# Staff Report

Re: PLNSUB2016-00421 & PLNPCM2015-00422 Richards Street Condos Planned Development and Conditional Building and Site Design Review

## Planned Development & Conditional Building and Site Design Review

Site Plan  
**AS101**

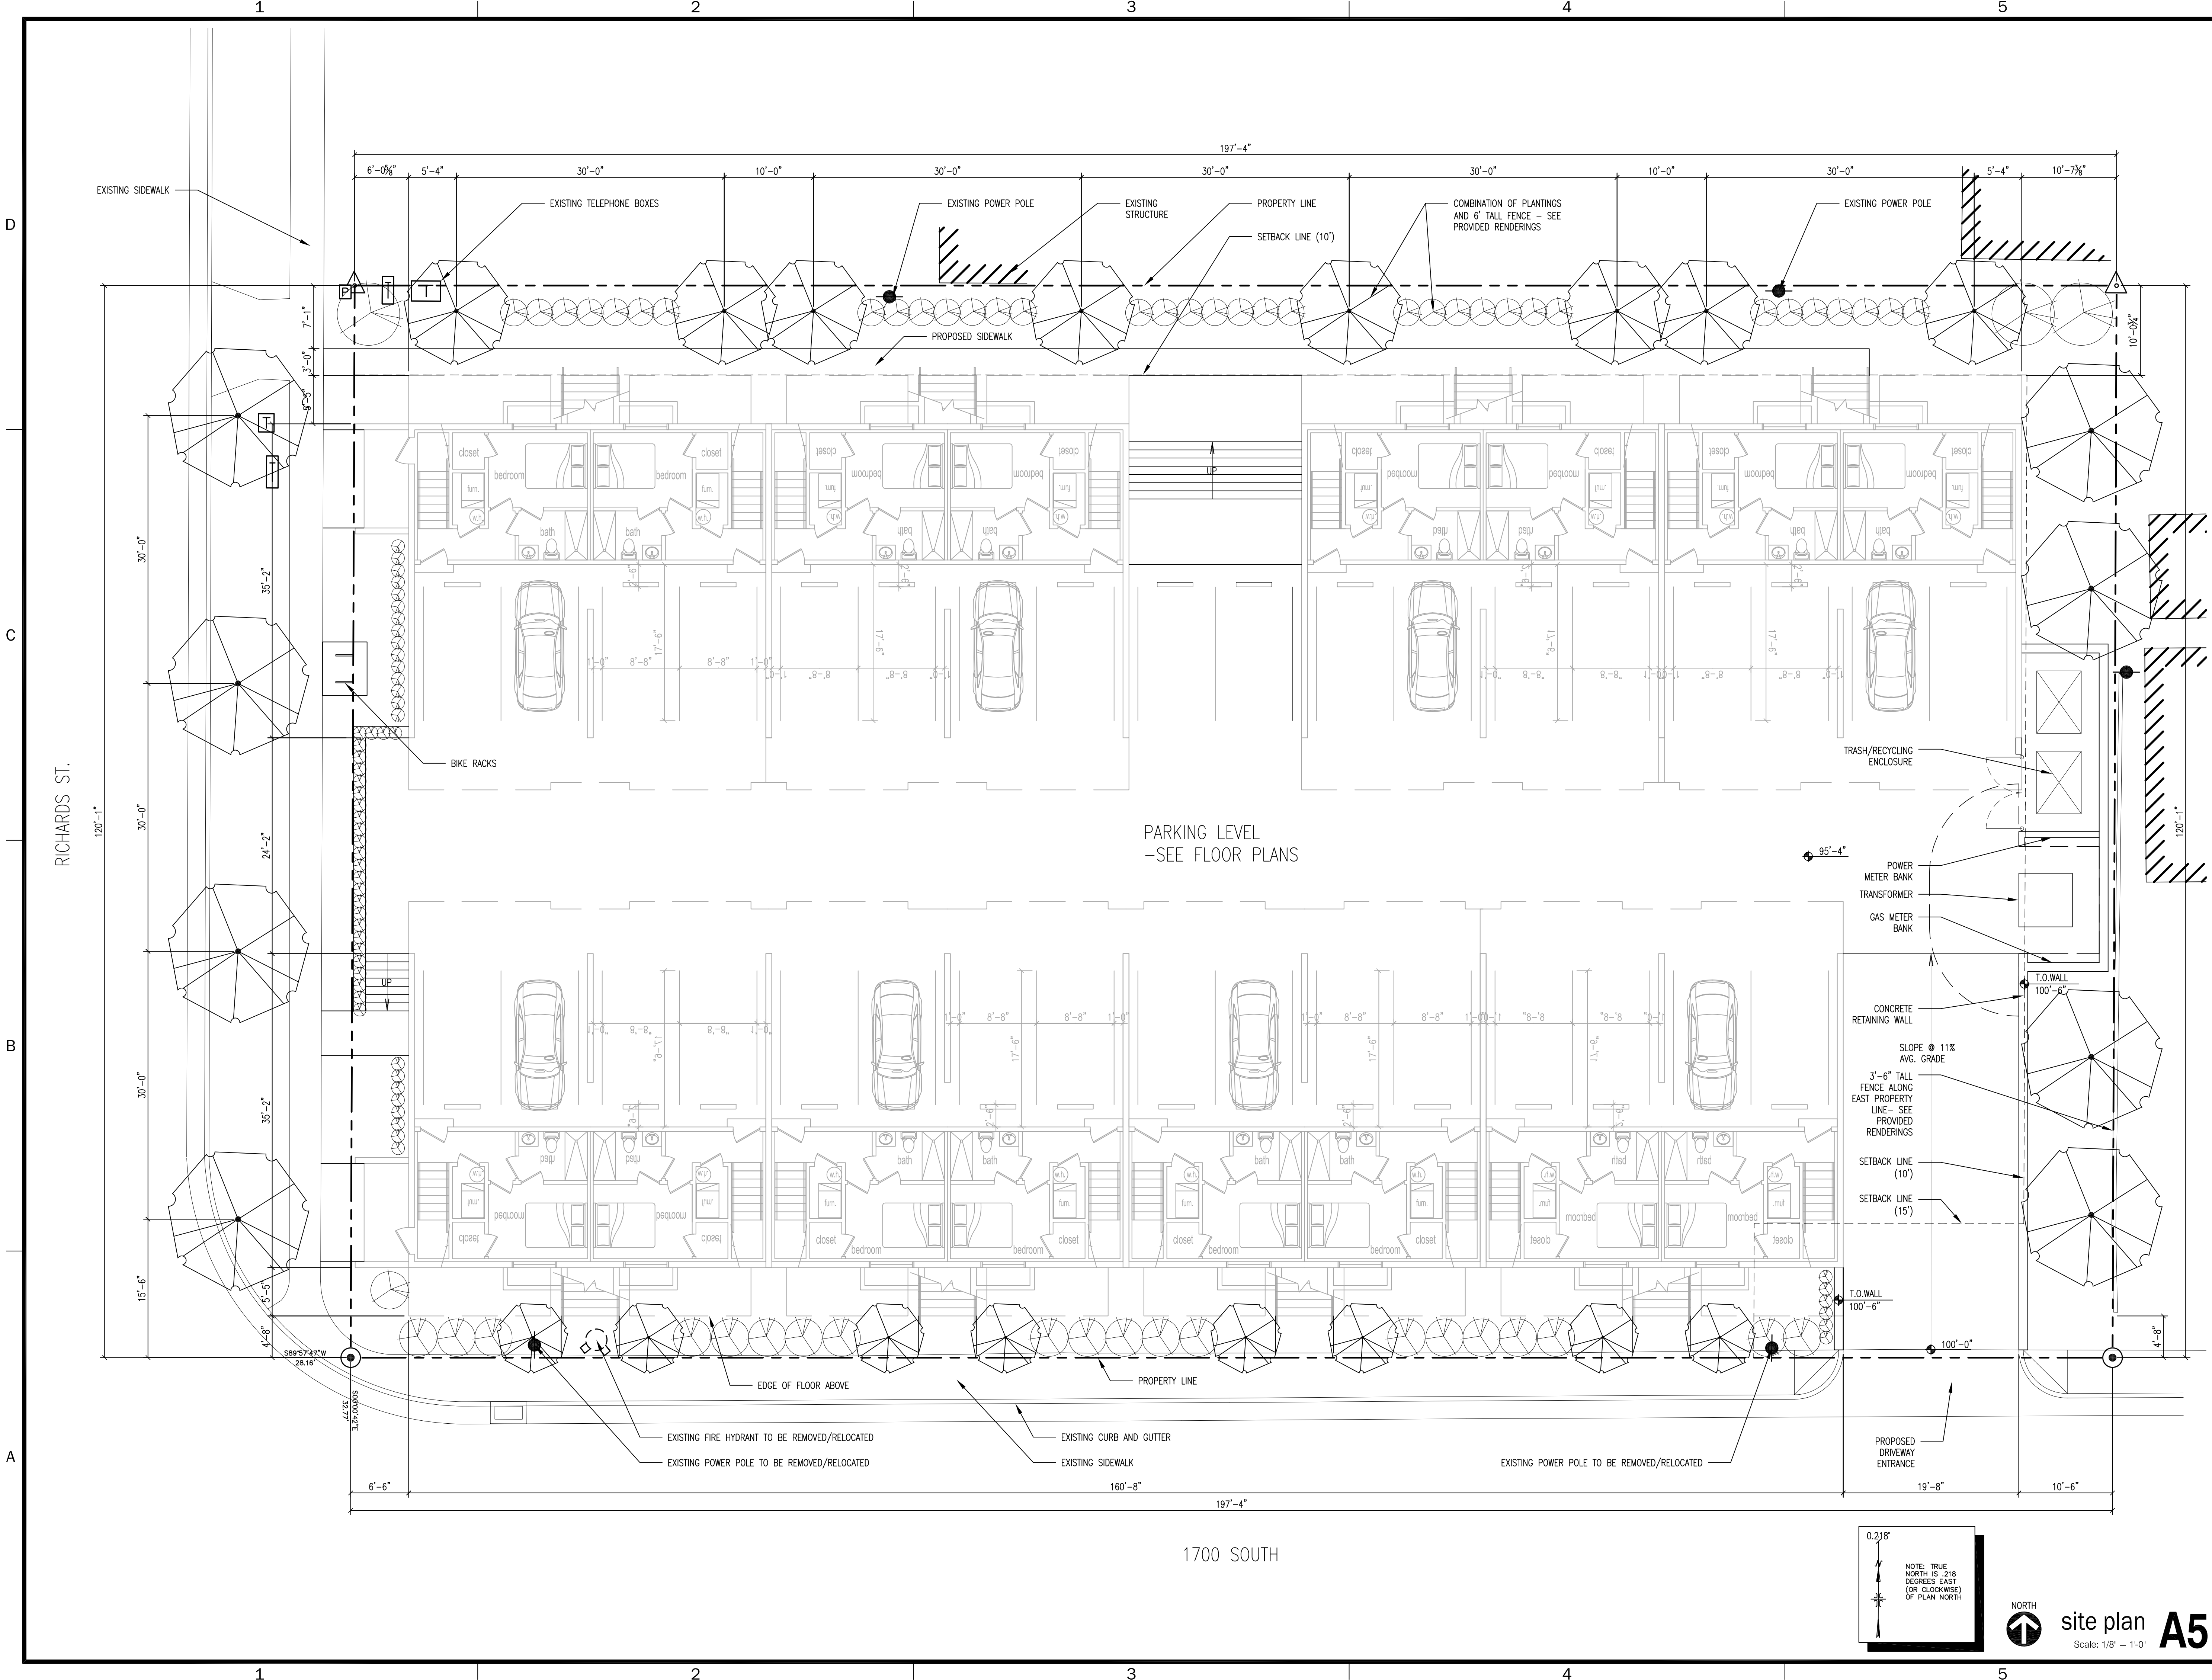
Provide complete parking calculations on site plan indicating the following:

- Minimum number of ADA parking spaces required (21A.44.020.D)
- Minimum number of passenger vehicle parking spaces required (21A.44.030.G)
- Minimum number of electric vehicle parking spaces required (21A.44.050.B.2)
- Minimum number of bicycle parking spaces required (21A.44.050.B.3)
- Minimum number of loading berths required (21A.44.080)
- Any modifications to parking requirements (21A.44.040)
- Number of parking spaces provided.

Driveway entrances shall comply with sight distance triangle requirements per 21A.40.120.E.

On street credit- yes, on Richards St., looks like 4 or 5 (22 ft. long stalls), NP 20 feet back from stop sign.

Sight Distance Triangle – It looks favorable.

Driveway maximum average slope is 16%, they shouldn't have a 11% break all at once; it should be gradual. I'd probably say no to the 2 spaces that are in front of the stairs, they need a clear pedestrian pathway.

Berth – I would give them credit for the berth as long as they don't block in any vehicles and could keep one lane of traffic open (in the driveway) so that cars could get in and out.
